RE: Water CCN Amendment Application – County Line Special Utility District
PUC Docket No. 50553
SWE Project No. 0017-063-18

On behalf of our client, County Line SUD, we are responding to your Memorandum dated March 16, 2020, regarding the deficiencies in the County Line SUD application to obtain a new sewer CCN.

MASTER CONCEPTUAL PLAN
FOR THE DEVELOPMENT OF
HARMONY HILLS
187.744 ACRES OF LAND
OUT OF THE THOMAS WESTBROOK SURVEY ABS 458
AND THE I & G N R R CO SURVEY ABS 577
HIGH ROAD
HAYS COUNTY, TEXAS

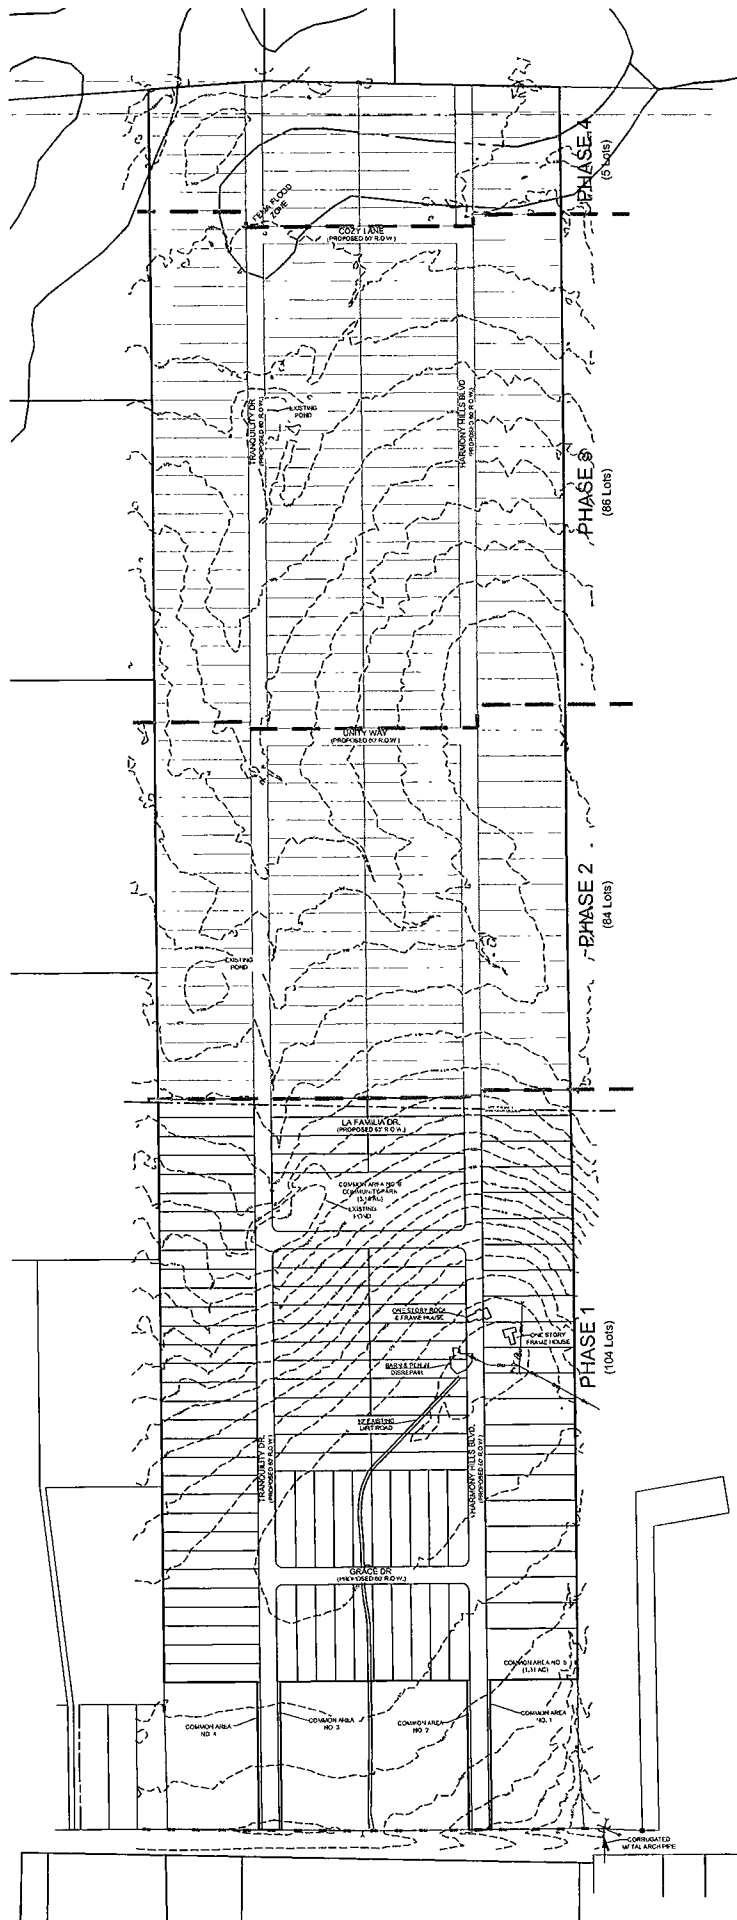
6. Technical Deficiencies:

- No plats have been recorded in the proposed areas. We do have a concept plan for the proposed Harmony Hills Subdivision that are enclosed.
- We do not have any TCEQ engineering approvals to serve the proposed amendment areas. No improvements are necessary to serve the area near High Road (Harmony Hills Subdivision), since County Line already has the facilities in place. No improvements are needed at this time to serve the proposed area along FM 2720.

Detailed Map - Area #1

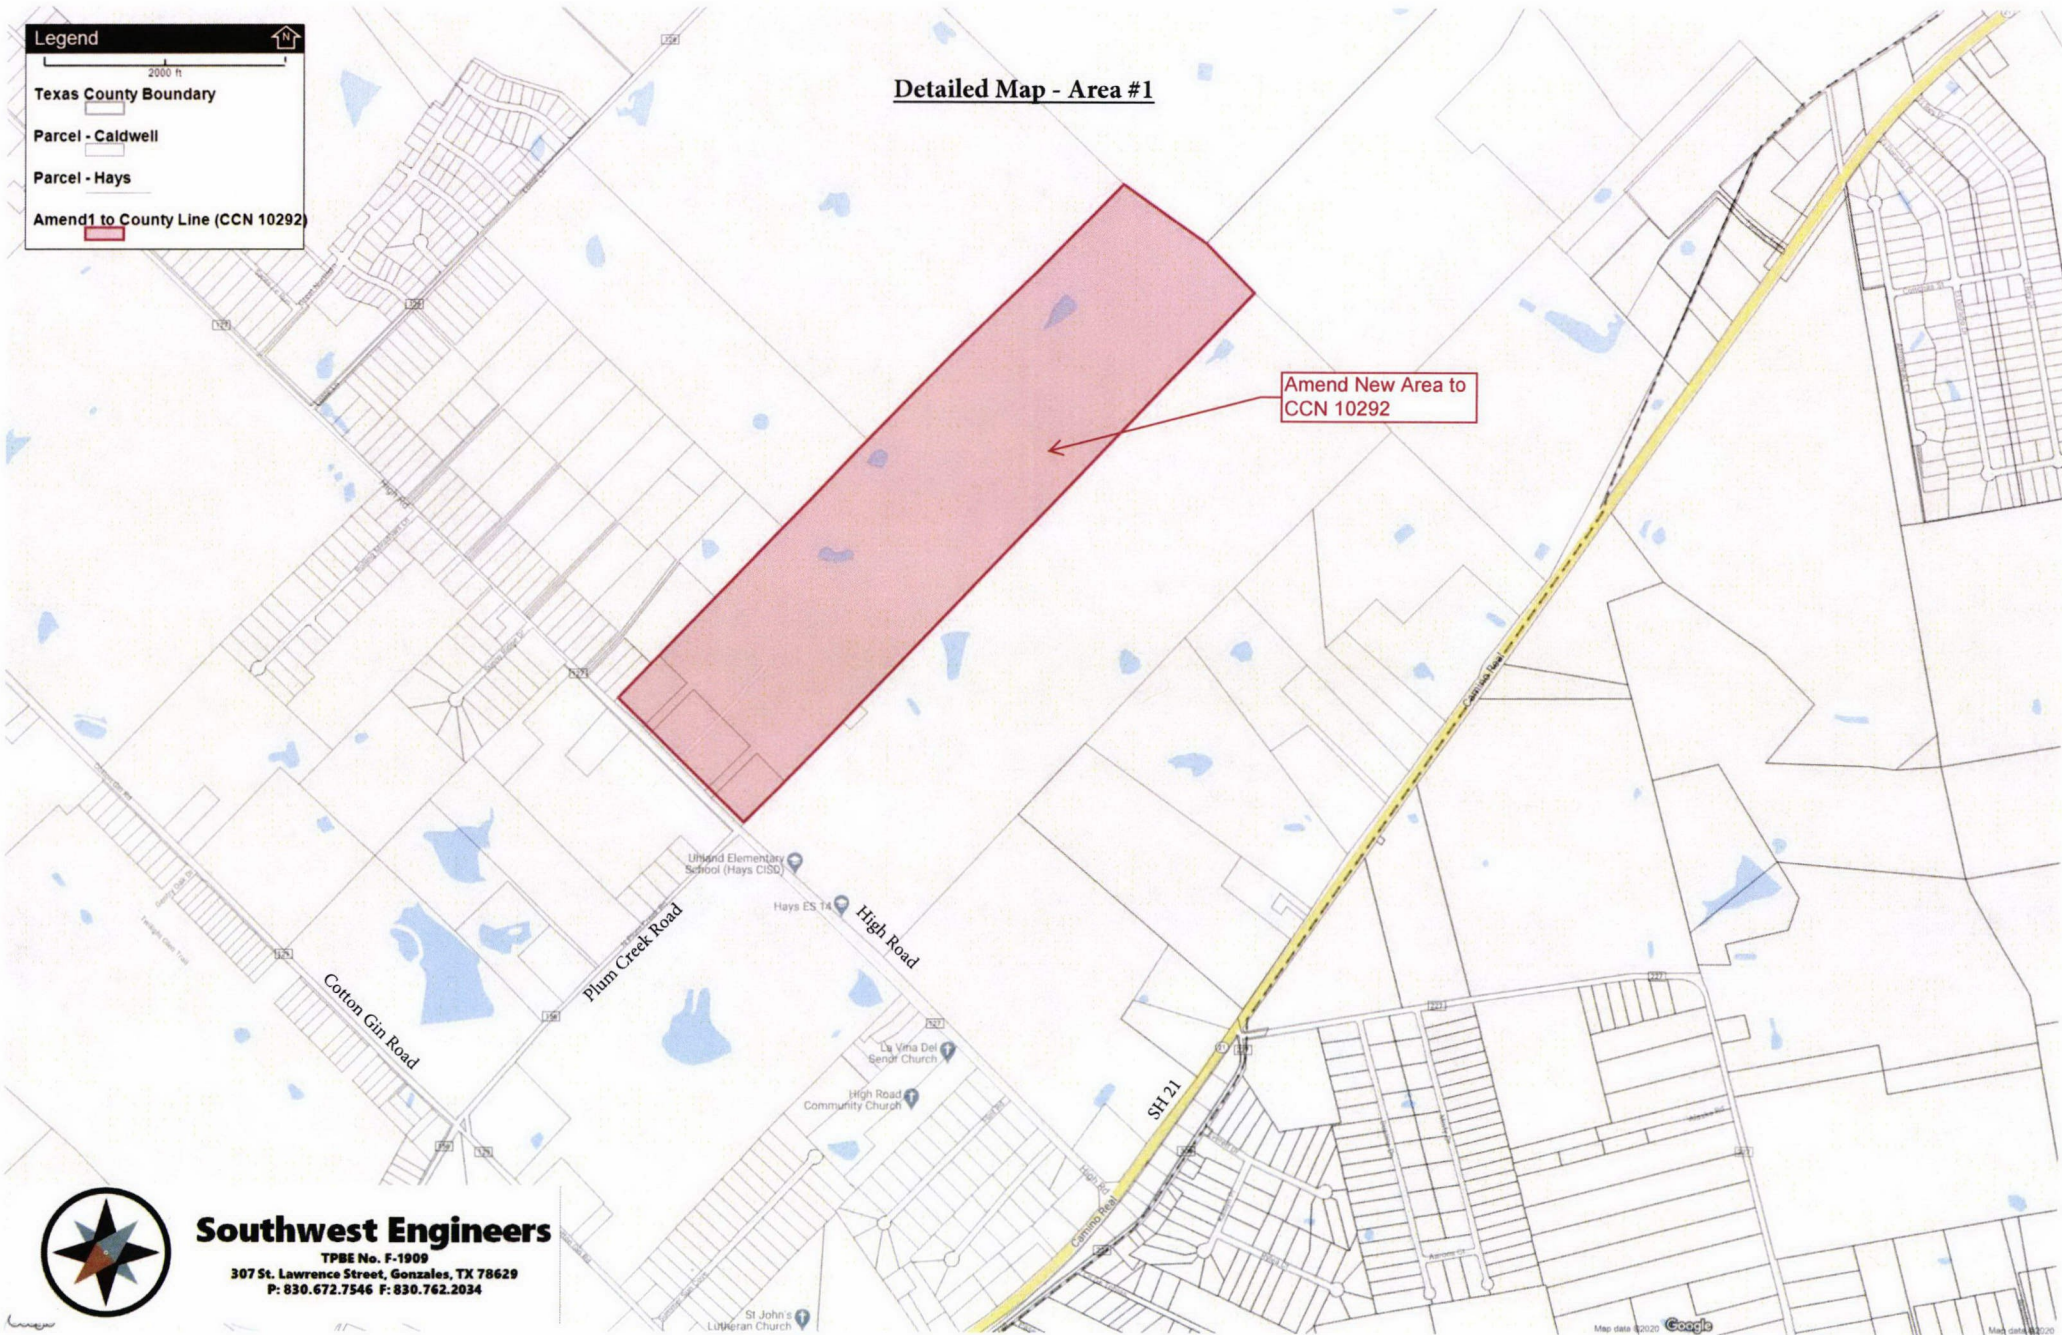
4. Mapping Deficiencies:

The maps were updated so there are no overlaps with other utilities. Revised maps are enclosed along with shape files. The boundary does not abut to Goforth SUD's CCN as we followed parcel boundaries provided by Hays County Appraisal District instead of Goforth SUD's existing CCN boundary.
